Strawman Amendment to Standard Air Interface for Fixed Broadband Wireless Access Systems in License Exempt Bands

**LAN MAN Standards Committee of the IEEE
Computer Society and the IEEE Microwave Theory and Techniques Society**

Strawman Amendment Standard Air Interface for Fixed Broadband Wireless Access Systems in License Exempt Bands

Figure 29—UL-MAP Information Element Ordering

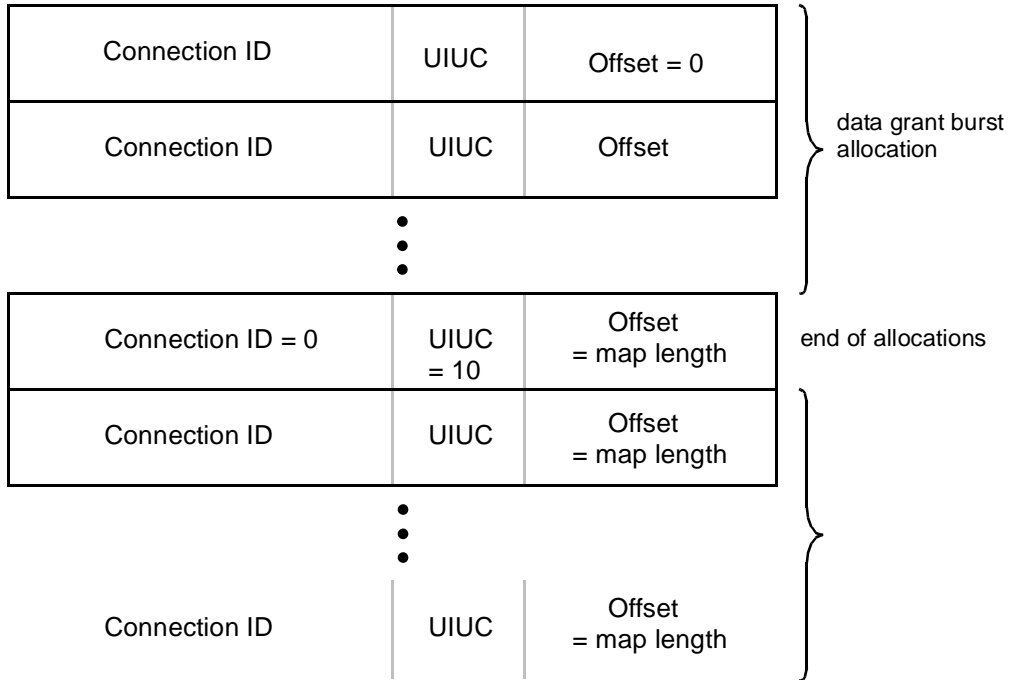
Please replace the Figure 29 graphic with the following:

1 Information elements define uplink bandwidth allocations and power control changes. Each UL-MAP mes-
 2 s-
 3 sage shall contain at least one Information Element that marks the end of the last allocated burst. The Infor-
 4 mation Elements are strictly ordered within the UL-MAP, as shown in Figure 29.

Figure 1—MSH-SCH Message Format (SS to SS)

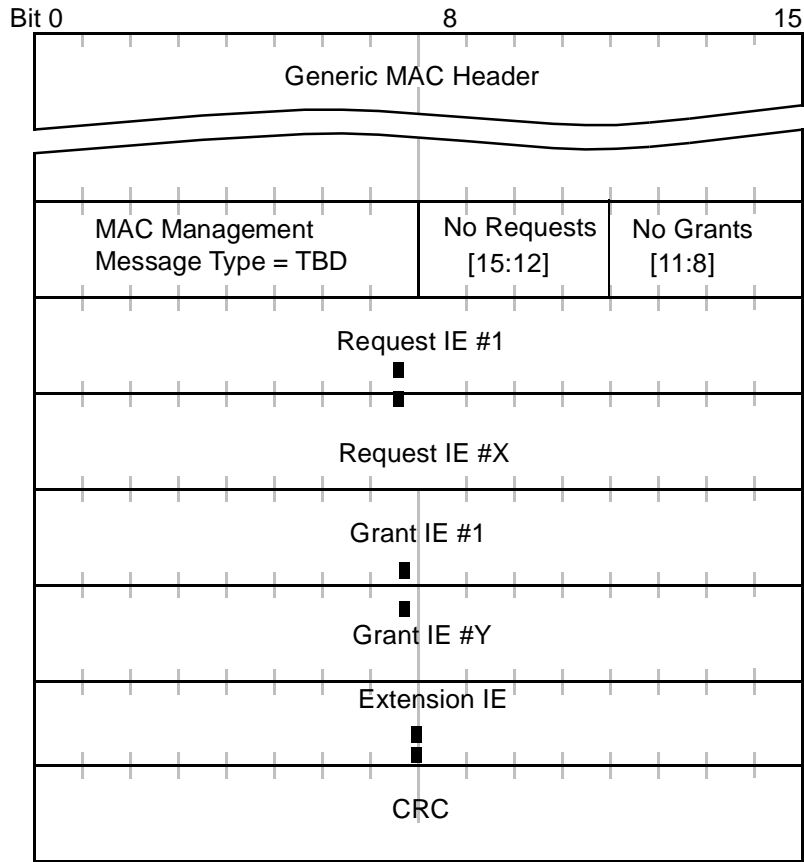
25
 26
 27 | *Please insert the following new subclause and figures*

32
 33
 34 A Mesh Schedule message shall be transmitted by all the stations in a mesh mode at a periodic interval to
 35 inform all the neighbors the schedule of the transmitting station. Each station shall determine its own unique
 36 Mesh Schedule message transmission time using the two-hop neighborhood information.

Figure 2—MSH-REQ Format (SS to SS)

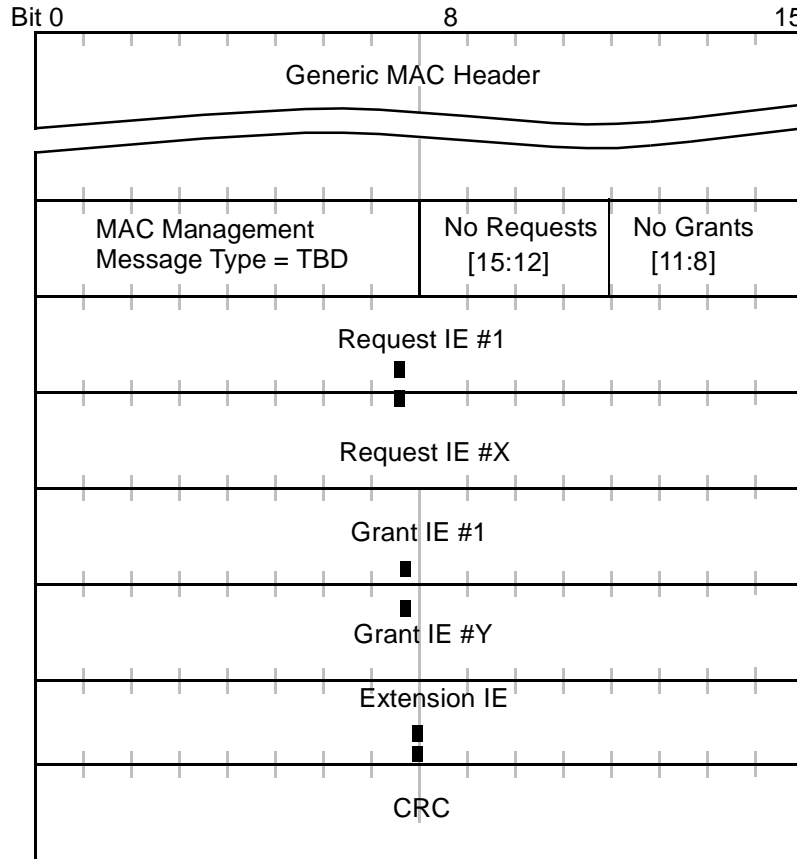
6.2.2.2.28.2 Mesh Mode Bandwidth Request IE
